**Technical Manual Insert**

**ADDITIONAL  
MAINTENANCE INSTRUCTIONS**

**NAVY TYPE ACB-1600HR  
CIRCUIT BREAKER**

**WESTINGHOUSE TYPE DBN-1016**

304 8531  
304C 398  
Fig. 1 - Mechanism Latch Adjustment

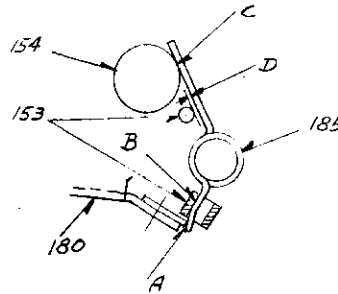
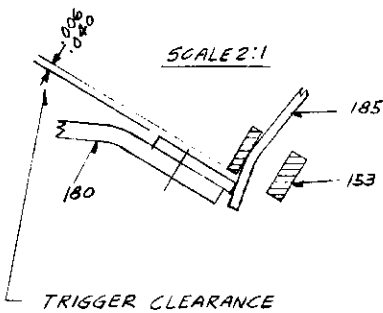
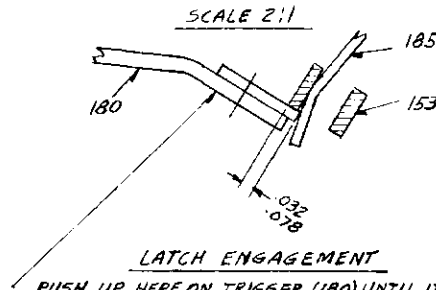
CHECK TO SEE IF TRIGGER (180) WILL RESET FROM THIS POSITION AND IF NECESSARY CLEAN AND REMOVE BURRS FROM SURFACE "E" ON LATCH (153)

WITH TRIGGER (180) TOUCHING SPRING (185) ON SURFACE "A" AND WITH SPRING (185) TOUCHING LATCH (153) ON SURFACE "B" THEN IF NECESSARY BEND UPPER END OF SPRING SO THAT SPRING

1. TOUCHES PIN (154) AT "C"
2. AND HAS ZERO TO .016 INCH CLEARANCE TO PIN PROJECTION OF LATCH (153) AT "D"

BEND END OF TRIGGER (180) IF NECESSARY TO ADJUST IF CLEARANCE IS LESS THAN .006 DO NOT BEND IF OVER .040 BUT CONTACT MANUFACTURERS REPRESENTATIVE

PUSH UP HERE ON TRIGGER (180) UNTIL IT TOUCHES LATCH (153) CHECK DIMENSION AND BEND END OF SPRING (185) IF NECESSARY

1. Failure of trip bar to reset, insufficient latch engagement, incorrect trigger clearance, or faulty latch position. See Figure 1 of this insert for details of inspection and correction.

1. Insufficient latch engagement, incorrect trigger clearance or faulty latch position. See Figure 1 for details.
  2. Any device which might hold trip bar in partially tripped position.
